ADDENDUM NUMBER 5
for
ADVANCED TREATMENT PROJECT
FORT THOMAS TREATMENT PLANT
NORTHERN KENTUCKY WATER DISTRICT

FROM: CH2M HILL
 TO: Plan Holders of Record

4005-526

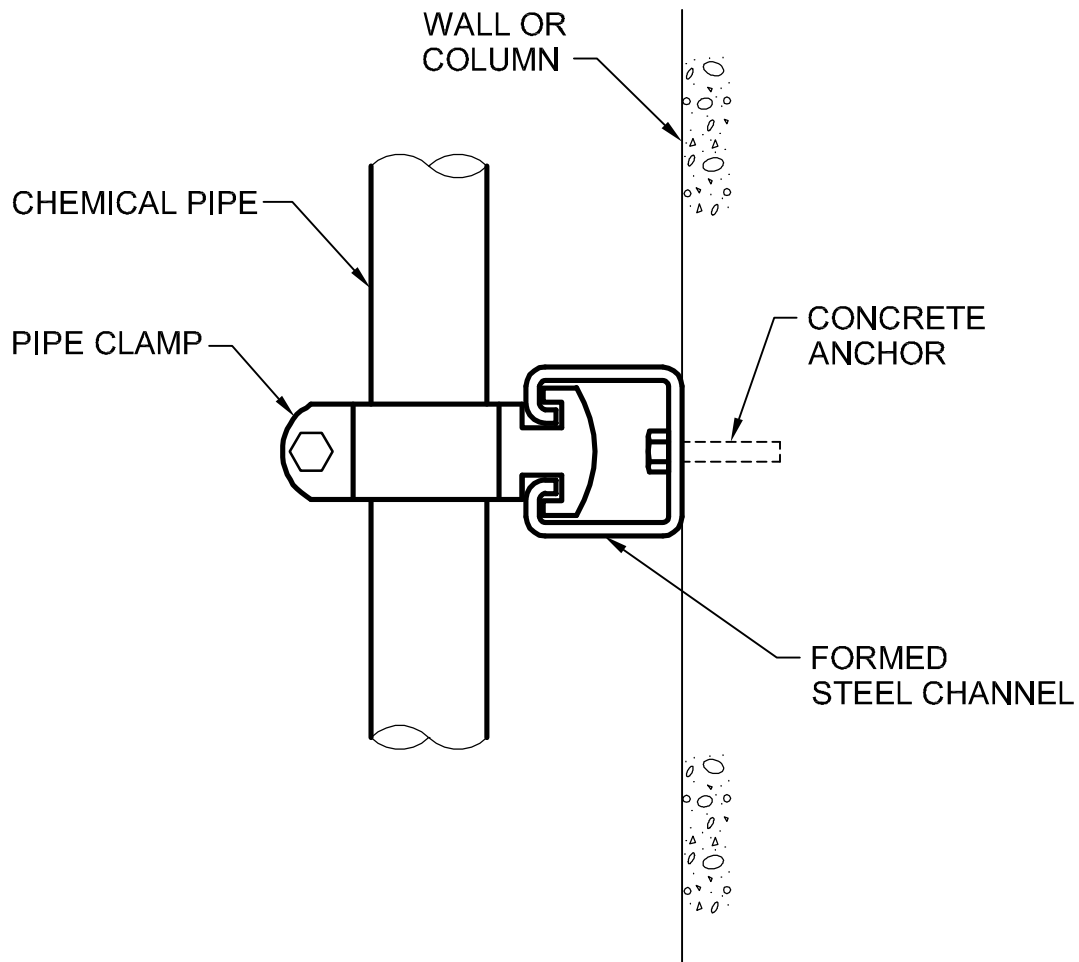
Add the detail number 4005-526 attached to this addendum.

CH2MHILL HDR
 PLUMBING
 AT BUILDING
 SECOND FLOOR
 SOUTH PLAN

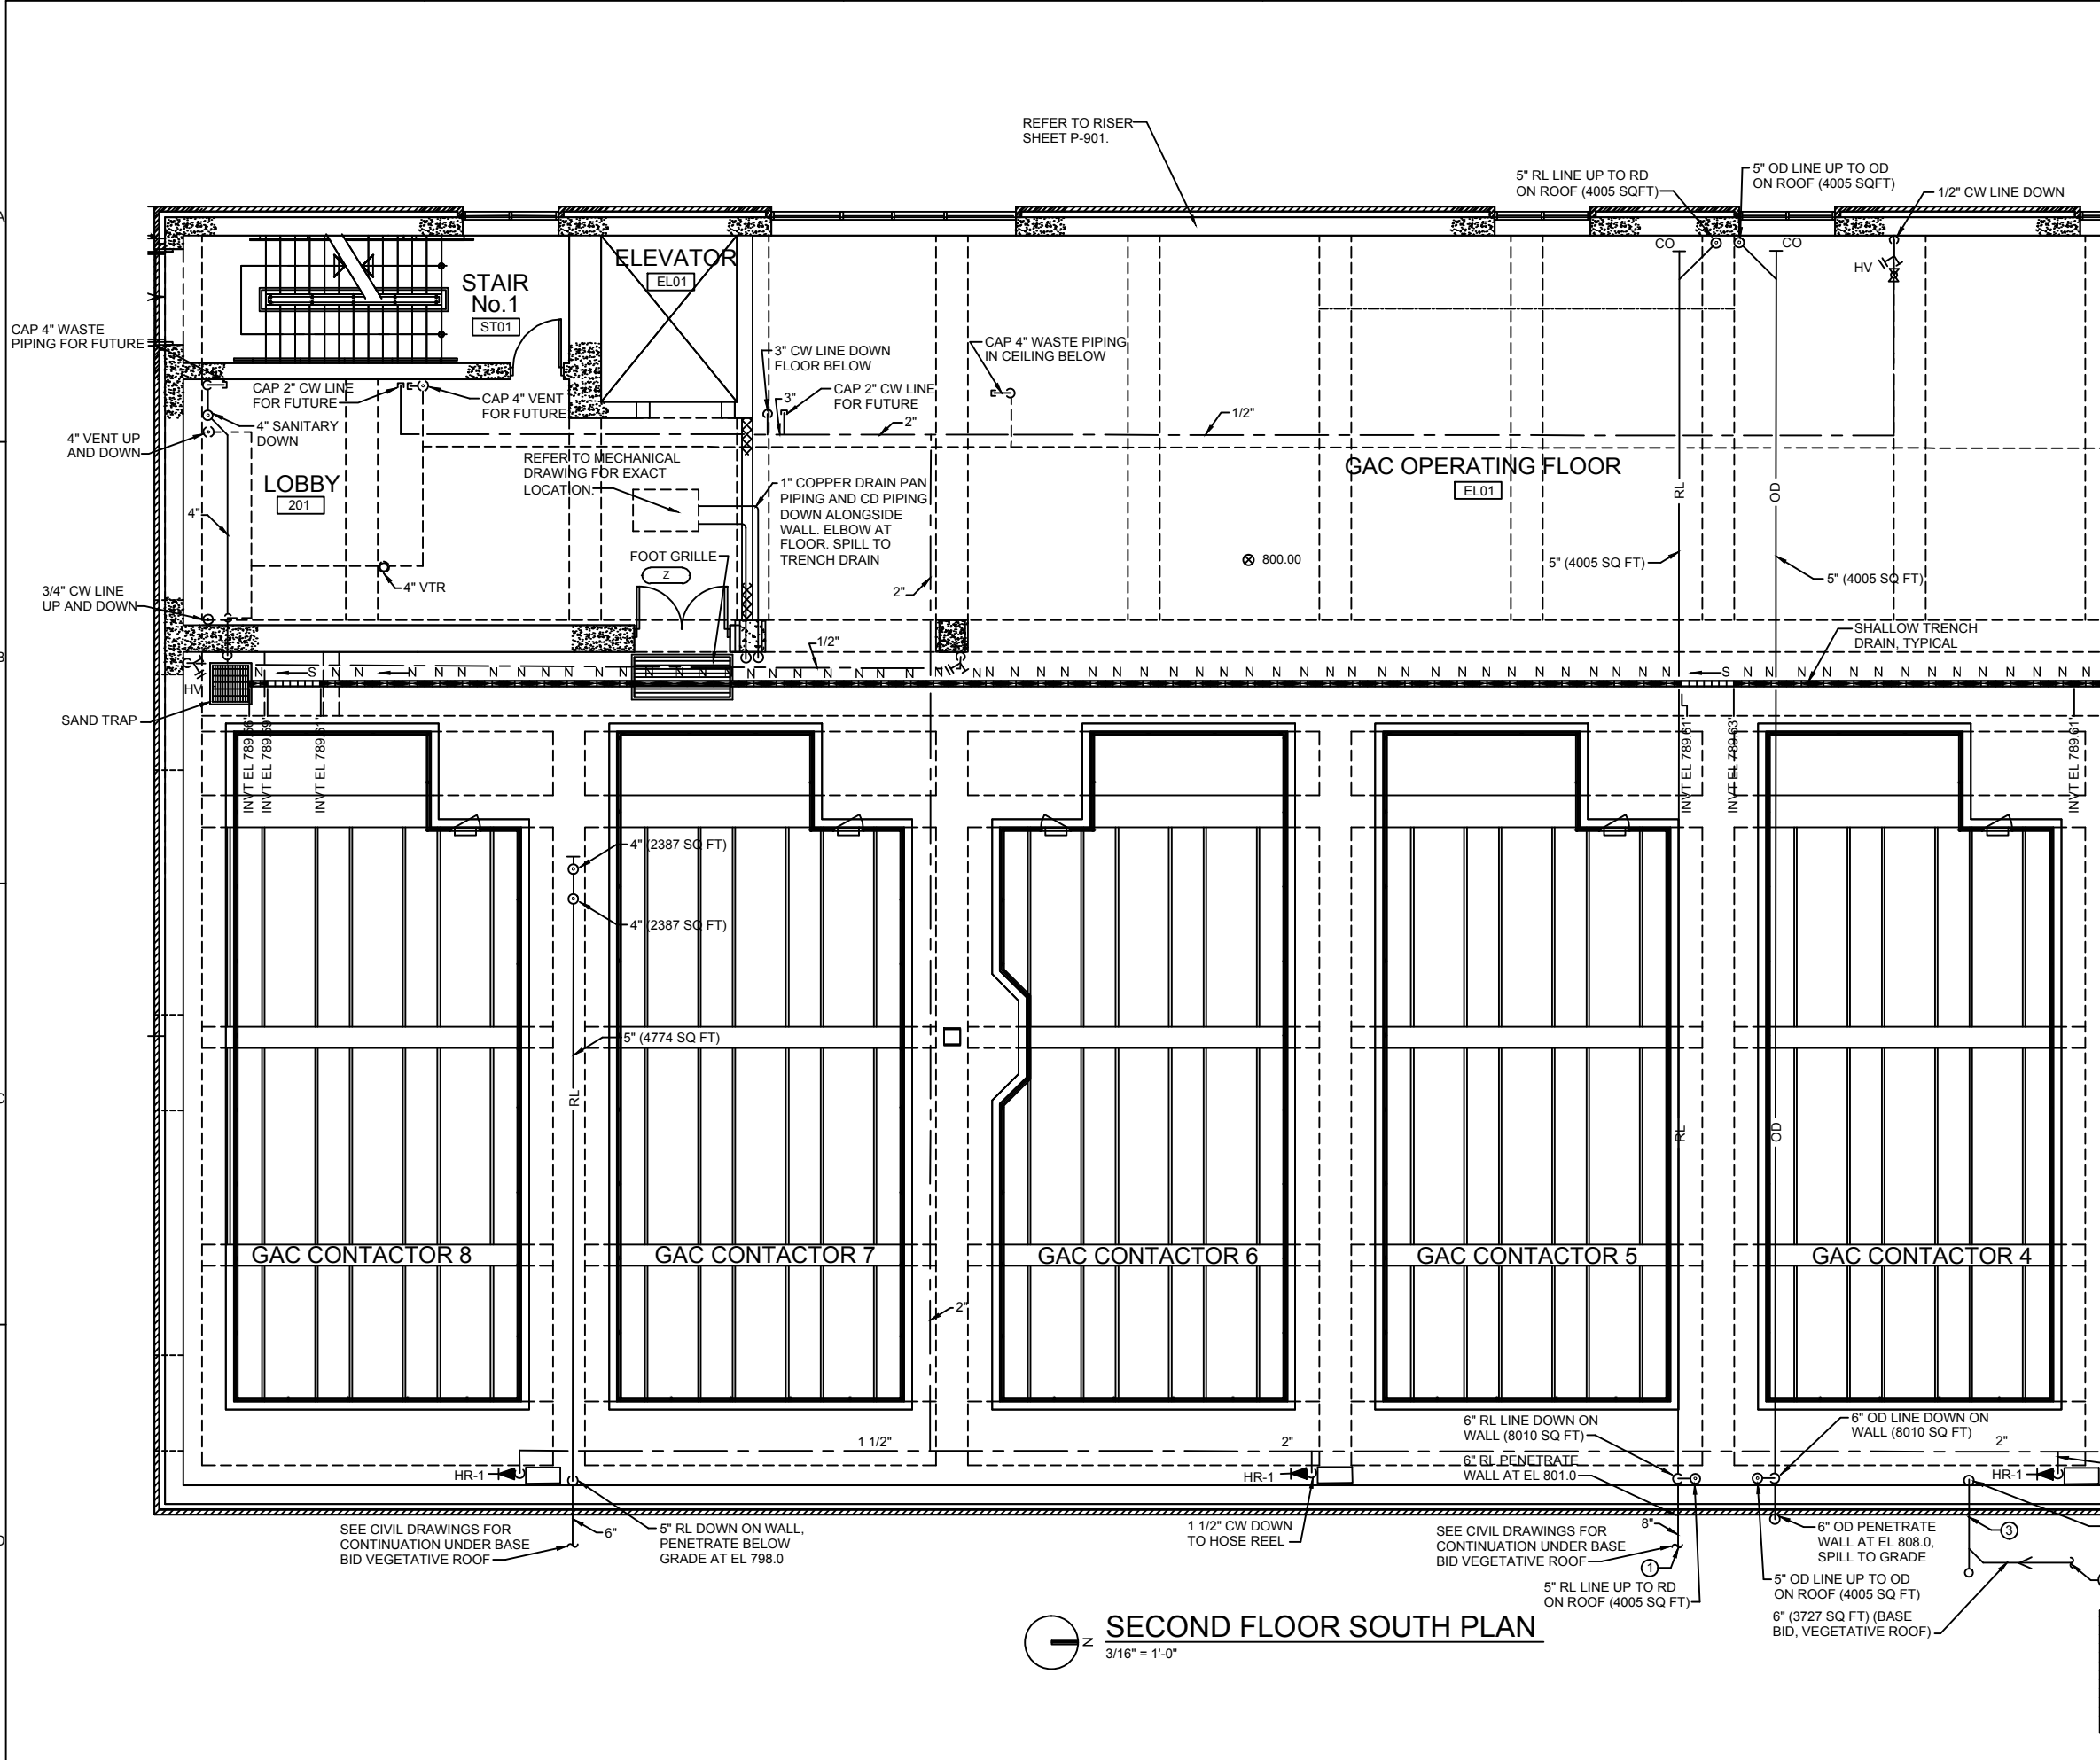
Contractor shall provide (3) 1 ½" Hose Reels with service shut off valves on East wall. Provide a 3" CW Line down to floor below (Sheet FT-P-141). Contractor shall provide (2) ½" Hose Valves (HV), one on South wall near Sand Trap and one on column between GAC Contactors: #6 & #7 (West). Provide water piping for Hose Reels & Hose Valves as indicated on revised drawing attached to this addendum.

As a clarification the revised drawing is intended to indicate changes related to hose valves, all items in prior addendums related to sheet FT-P-151 remain in effect.
